May 5, 2015

01261-01904 Version 3

## Safety Recall: Headlight LED Lens Film Delaminates

Supersedes 14-051, dated January 22, 2015, to revise the information highlighted in **yellow**

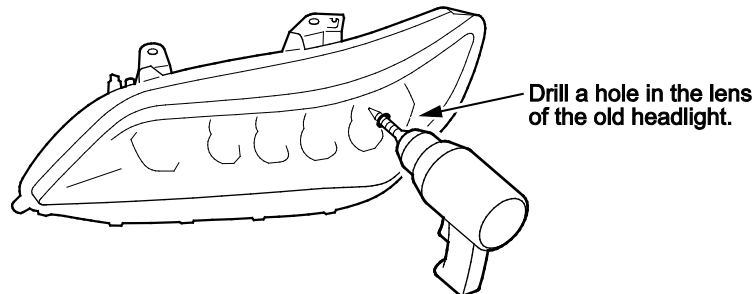
NOTE: To differentiate the original head light assemblies from the improved ones, the improved assemblies have the letter "O" in front of the ID code.
